TOWN OF PLAINFIELD DESIGN REVIEW COMMITTEE REPORT

CASE NO.: [DP-21-074](#)

PETITIONER: Browning Investments

REQUESTED ACTIONS: Architectural and Site Design Approval of a 715,307 square foot speculative distribution building on a 43.94 acre parcel zoned *I-2: Office/Warehouse Distribution* including Development Incentives.

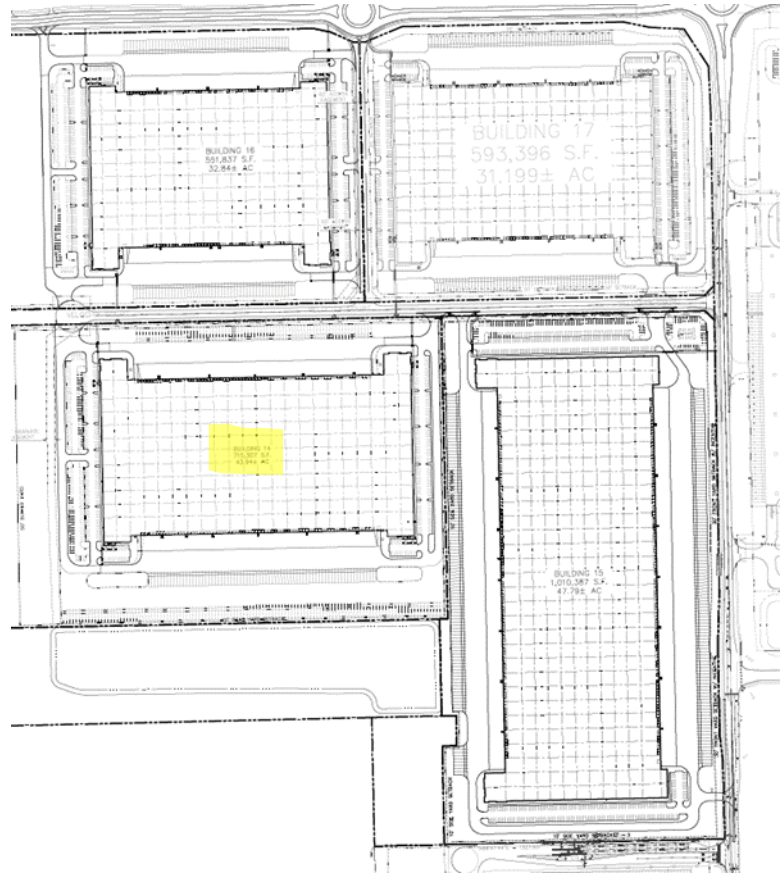
1. **Minimum Yards and Building Setbacks:** Does not comply. The applicant has sought Depth of Yard Development Incentive to gain compliance, but Sketch Plan One and Sketch Plan Two have not been submitted.

12. **Perimeter Yard Landscaping:** **Does not comply. Utilization of the Depth of Yard Development Incentive would require the Plant Unit Value to be at least 2.0, not the 1.0 that has been shown.** The southern perimeter landscape has been moved to the common area south of the property. This could be considered as an alternative landscape plan.

13. **Parking Lot Trees:** **Complies.**
14. **Parking Lot Screening:** **Does not comply—no screening provided on the east or west car parks as per ordinance.**

15. **Foundation Landscaping:** **According to the plan, no foundation landscaping has been provided.**
16. **Signs:** No information about signs has been submitted beyond general monument sign location. **The sign does not appear to comply with the proper setback requirements on the southeast side.**
